AMENDMENTS TO THE DRAWINGS

REMARKS

REPLACEMENT SHEETS FOR FIGURES 1-21

ANNOTATED SHEET SHOWING CHANGES TO FIGURE 7

FIG. 7
(PRIOR ART)

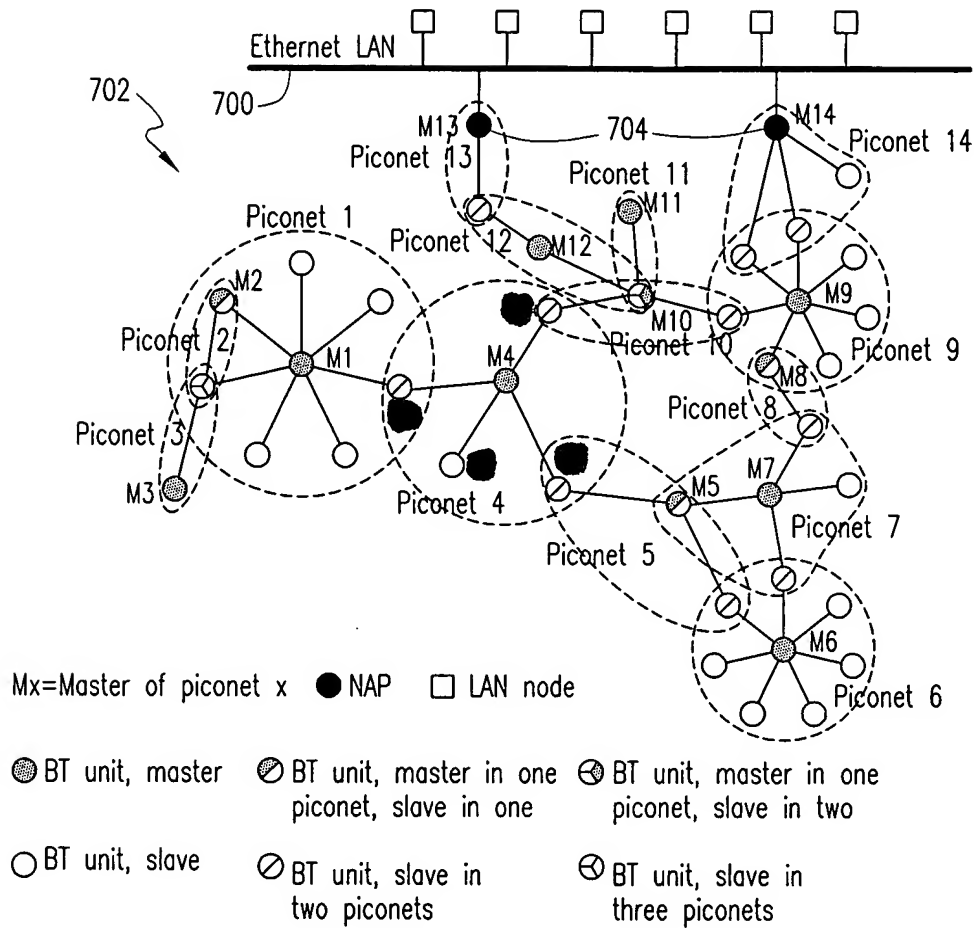
Figure 7 of the drawings is hereby amended to add the reference labels "S1," "S2," "S3," and "S4" to the four nodes directly connected to node "M4." Support for the amendment may be found in the specification in the paragraph bridging pages 31 and 32.
